FCC ID: PD9AX210D2
IC: 1000M-AX210D2

FCC/IC Label & Location for Intel Models using form factor D2

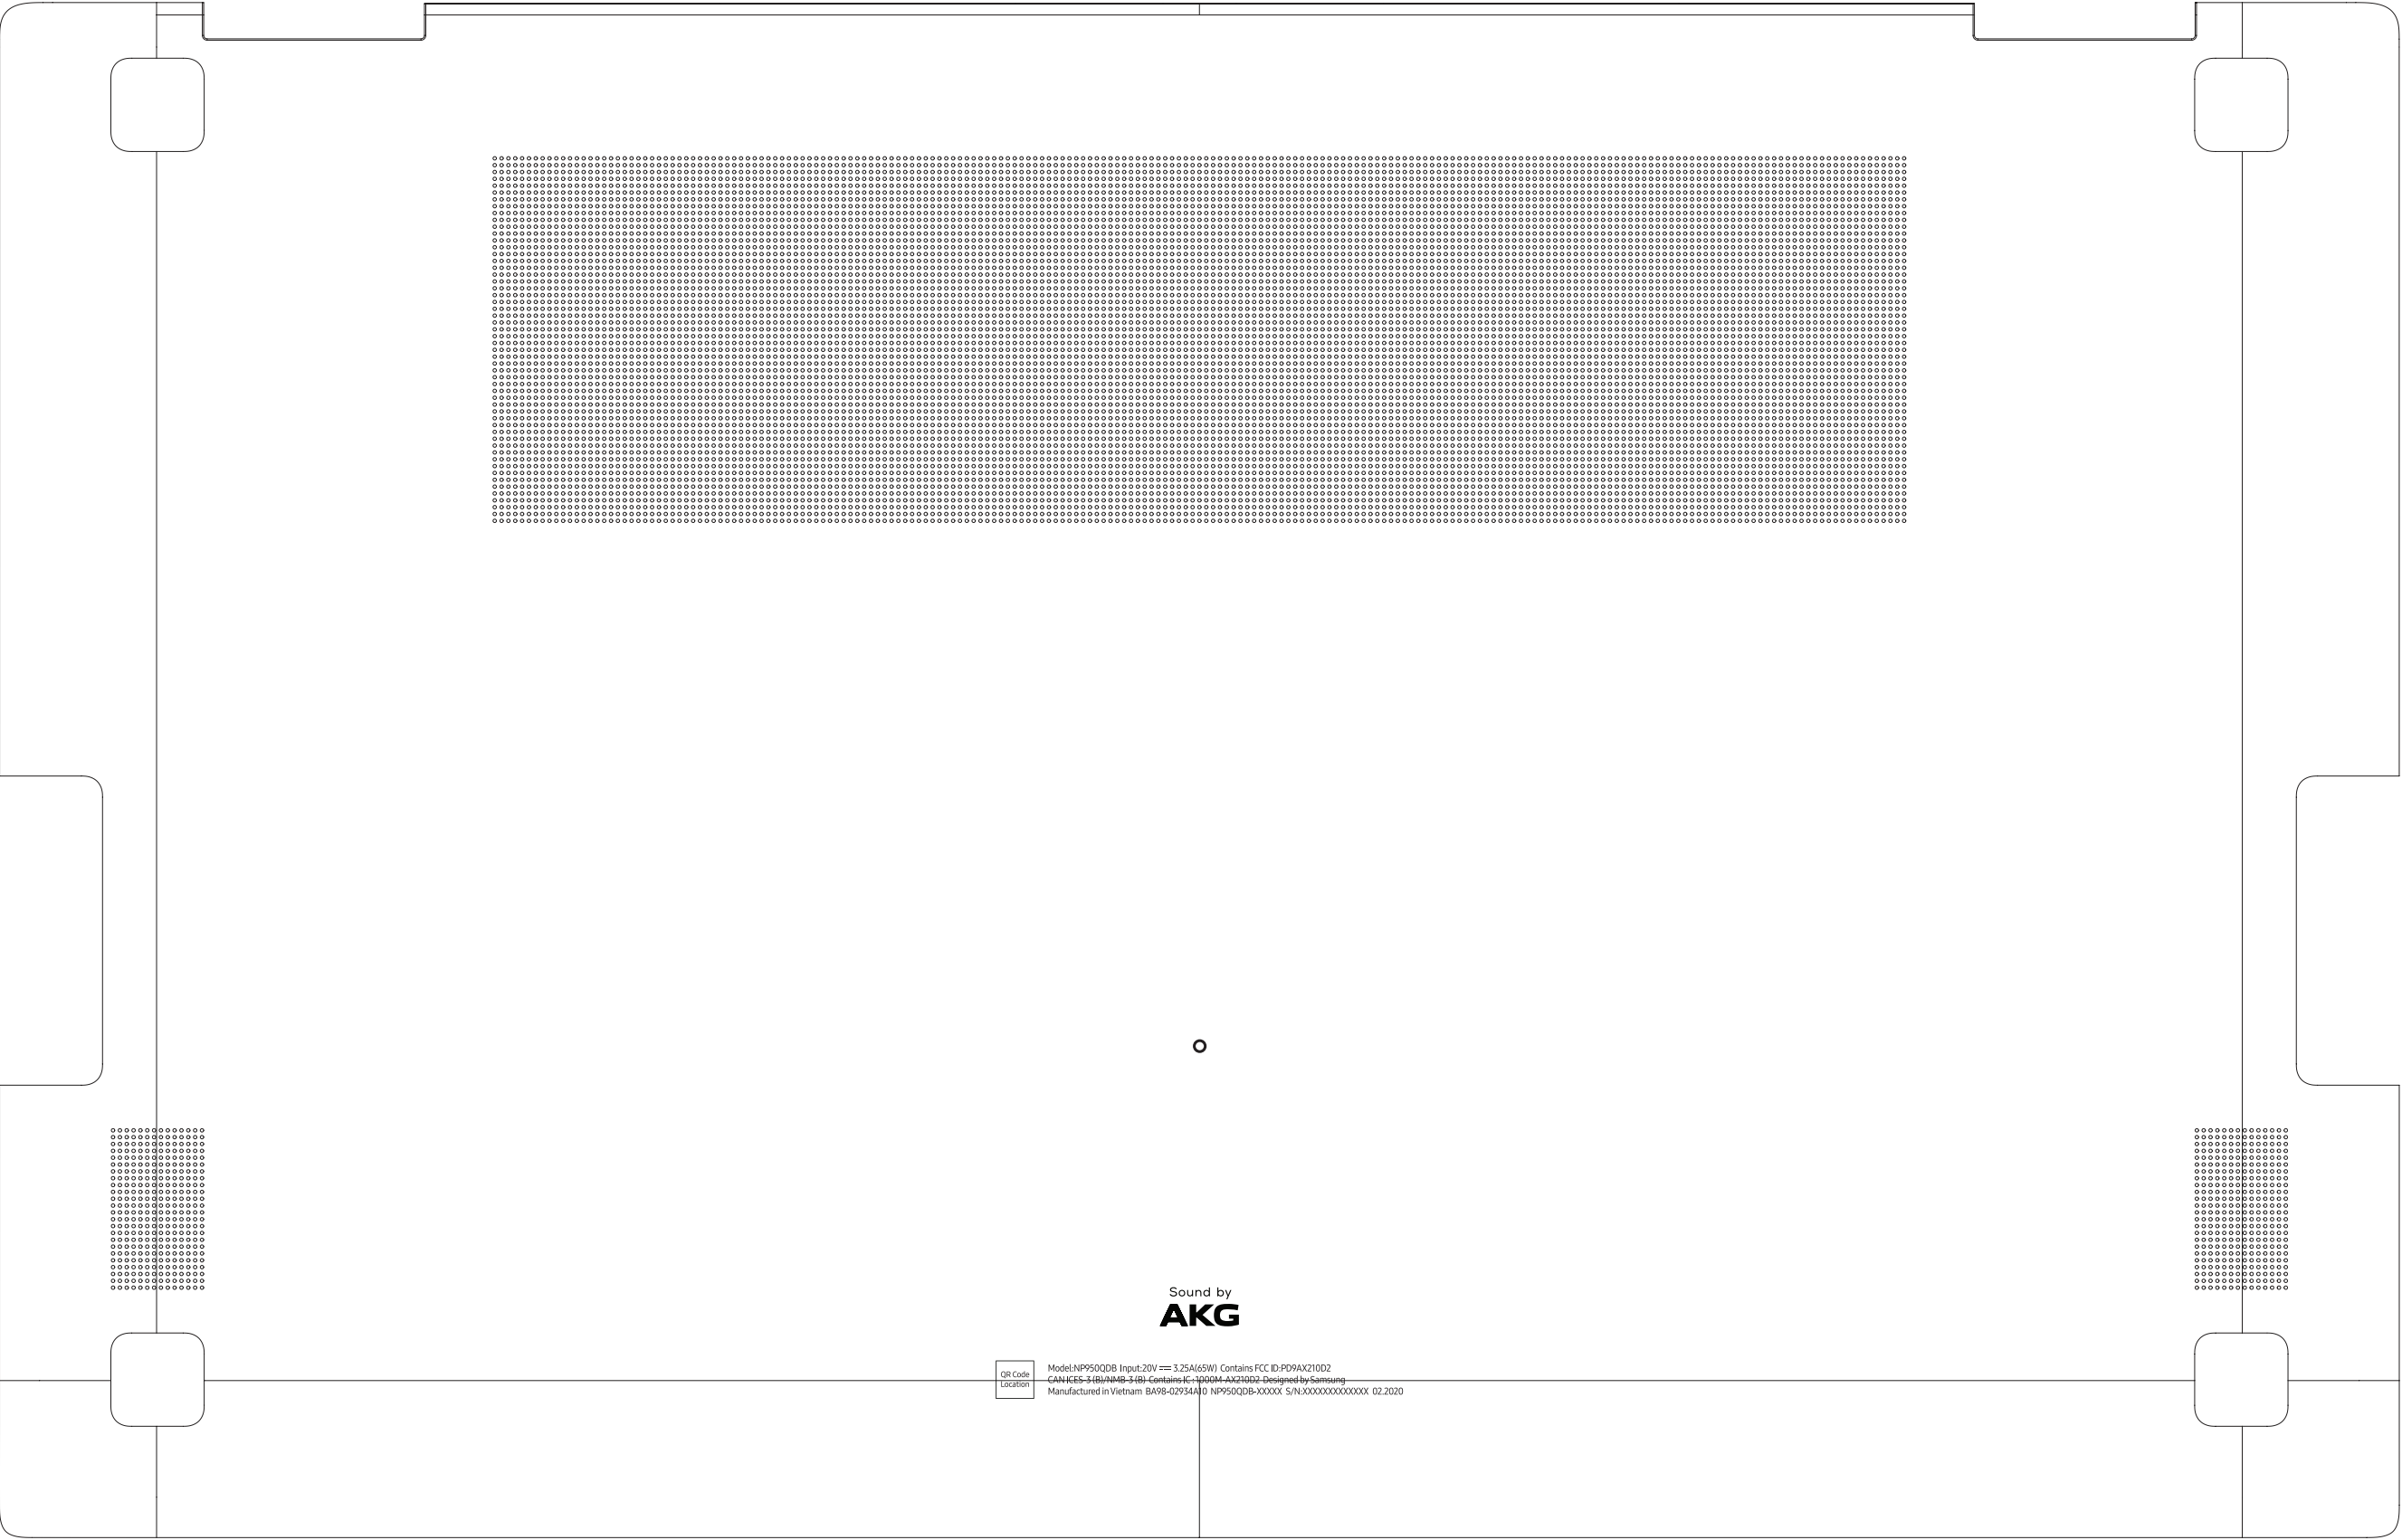
The device is considered to be too small for the label since it is impracticable to label with a font size that is four-points or larger. The FCC ID is instead placed in the users manual as allowed by KDB 784748 and as allowed by ISED previously on this form factor.

- FCC: Per KDB 784748 the marking may be placed in the user manual if the device is unquestionably too small to be readable (smaller than 4-6 pt font).
- IC: Per RSS-GEN 4.1 – If the dimensions of the product are extremely small or it is not practical to place the label or marking on the product....the label shall be placed in a prominent location in the users manual supplied with the product, as agreed upon with ISED prior to the certification application.
- The D2 models are considered to meet this criteria since the module size is 12mm x 16mm and 4pt font is the largest that can be used for module labeling which requires magnification for clear viewing.

Due to size, only the manufacturer ID & model number will appear on the module for identification.

Label exemption would be acceptable for this device. Please place the label information in accompanying literature.

The Certifications Numbers: FCC (per KDB 784748) and with ISED's permission will be displayed in the Uses Guide.
